Access Compliance Report Public Rights-of-Way (Curb Ramps)

Main Street: SPRING_ST Cross Street: N_GLENROSE_DR Location: NW

ADA ID: RPAT210927112458 Ramp Type: Type 1 - Perpendicular Diagonal Initial Pass/Fail: Fail Overall Compliance: No Severity Score: 15

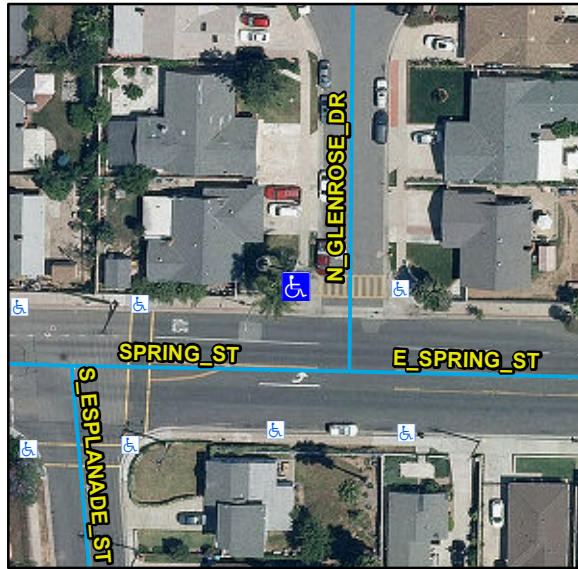
Compliance	Description	Data	Compliance	Description	Data
N/A	Ramp Length (in)	90	N/A	Flare Type LT	
Yes	Ramp Width (in)	50			N/A
No	Ramp Run Slope (%)	10.8	N/A	Flare Slope LT (%)	N/A
Yes	Ramp Cross Slope (%)	0.8	N/A	Flare Traversable LT	N/A
N/A	Landing Present	N/A	N/A	Flare Type RT	
N/A	Landing Length (in)	N/A			N/A
N/A	Landing Width (in)	N/A	N/A	Flare Slope RT (%)	N/A
N/A	Landing Run Slope (%)	N/A	N/A	Flare Traversable RT	N/A
N/A	Landing Cross Slope (%)	N/A	N/A	DWS Provided	N/A
N/A	Landing Movement Obstructed?	N/A	N/A	DWS Contrast	N/A
	Landing Movement Type	N/A	N/A	DWS Length (in)	N/A
N/A	Landing Shared	N/A	N/A	DWS Full Width	N/A
N/A	Clear Space	Yes	N/A	DWS Offset Left (in)	N/A
N/A	Clear Space To Crosswalk (in)	N/A	N/A	DWS Offset Right (in)	N/A
N/A	Marked Crosswalk 1	No	N/A	Marked Crosswalk 2	Yes
	Crossing 1 Direction	S		Crossing 2 Direction	E
	Marked Crosswalk 1 Width (in)	N/A		Marked Crosswalk 2 Width (in)	120

N/A	Ramp Inside Crosswalk 1	N/A	Yes	Ramp Inside Crosswalk 2	No
	Crossing 1 Slope (%)	7		Crossing 2 Slope (%)	0.6
	Crossing 1 Cross Slope (%)	0.8		Crossing 2 Cross Slope (%)	3.6
N/A	Gutter Ponding	N/A	N/A	Curb Slope	3.9
Yes	Gutter Lip Height (in)	0		Road Run Slope (%)	0.8
N/A	Gutter Run Slope (%)	N/A		Road Cross Slope (%)	0.7
N/A	Gutter Cross Slope (%)	N/A			
Yes	Overall Surface Condition: Acceptable		Yes	Perp Joint Present	Yes
	Cross Gutter Present?	Yes		Spandrel Present?	Yes
	Replace Cross Gutter?	No		Replace Spandrel?	No

Remove & Replace Curb Ramp With Two New Directional Ramps or Equivalent. Restripe Crosswalk.

R304.2.2, STD 1115
